SUBJECT: STORAGE OF CONSOLIDATED FUEL

Re: R. E. Ginna Nuclear Power Plant

Amendment No.12  
License No. DPR-18

SAFETY EVALUATION BY THE OFFICE OF NUCLEAR REACTOR REGULATION  
SUPPORTING AMENDMENT NO.12 TO FACILITY OPERATING LICENSE NO. DPR-18  
ROCHESTER GAS AND ELECTRIC CORPORATION  
R. E. GINNA NUCLEAR POWER PLANT  
DOCKET NO. 50-244

FIGURE 5.4-1  
SPENT FUEL STORAGE RACKS

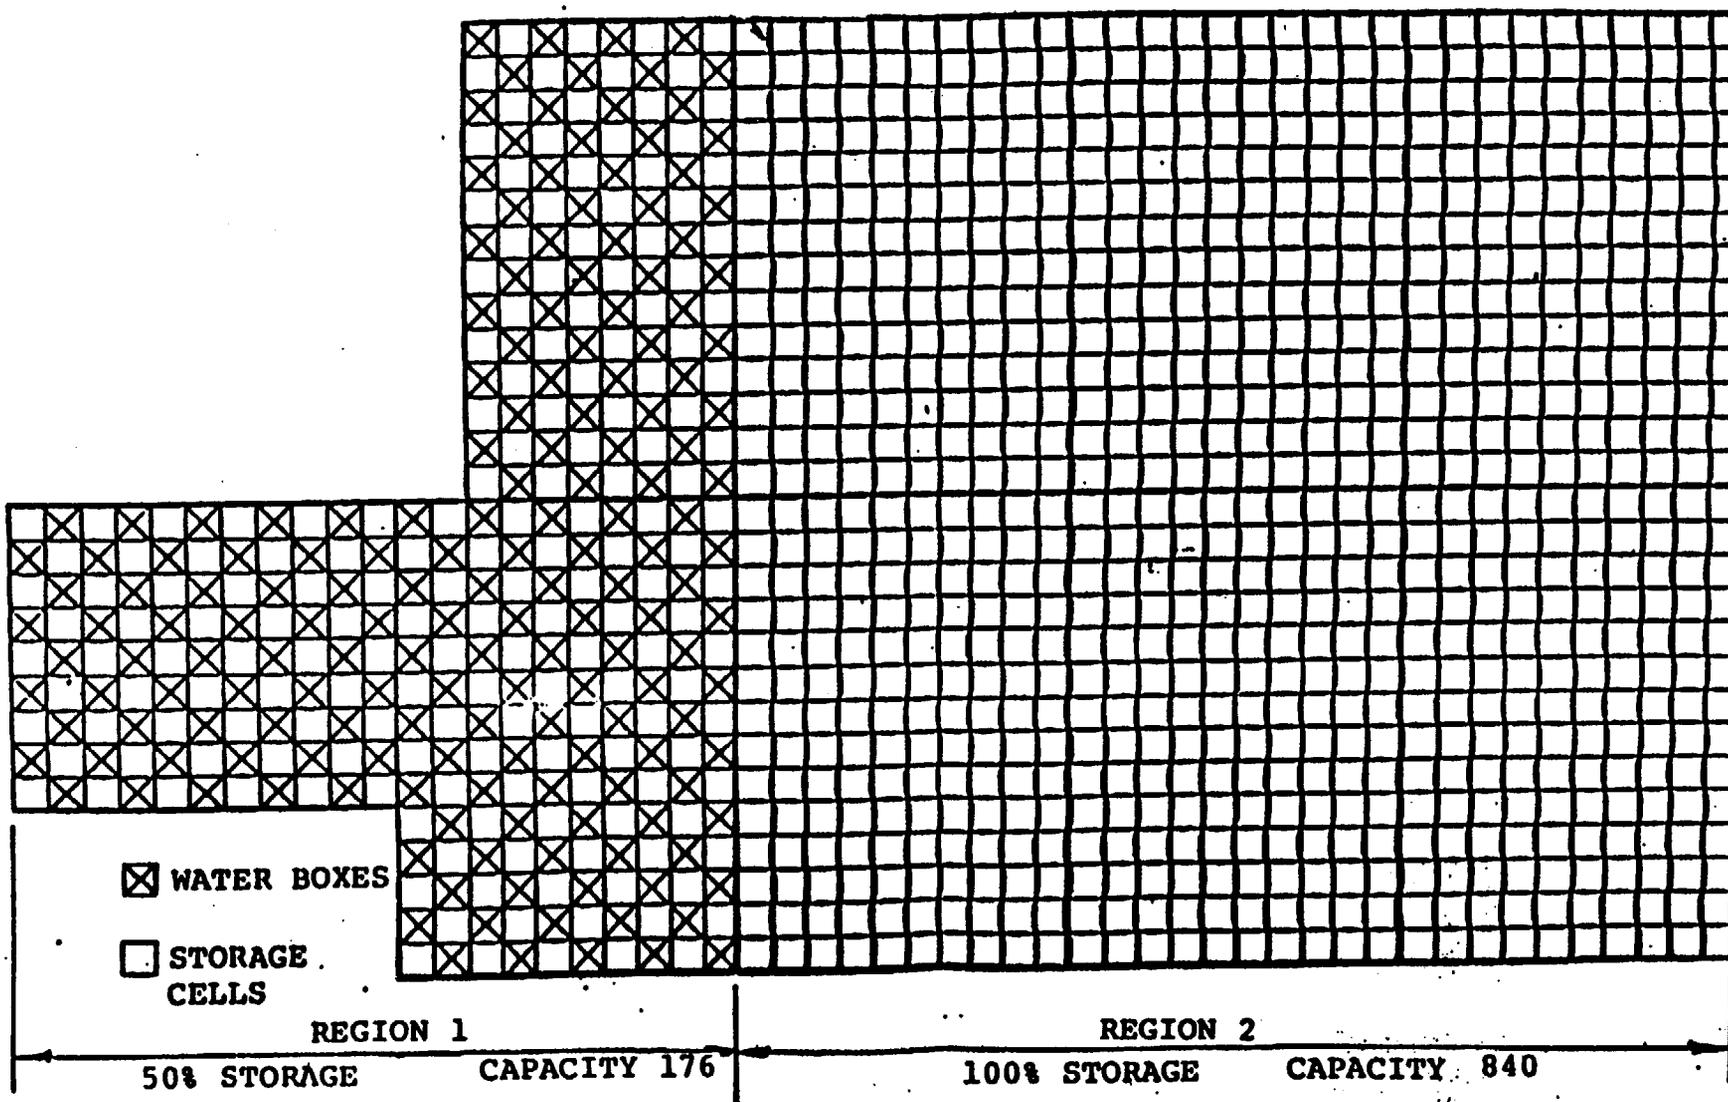
With the addition of the storage of consolidated fuel cannisters, the theoretical storage capacity of the pool would be increased to 2032 fuel assemblies (2x1016). However, due to limitation on the heat removal capability of the spent fuel pool cooling system, the storage capacity is limited to 1016 fuel assemblies.<sup>5</sup>

\*Total Capacity includes provisions for storage of consolidated fuel.

\*TOTAL CAPACITY 1016 Fuel Assemblies
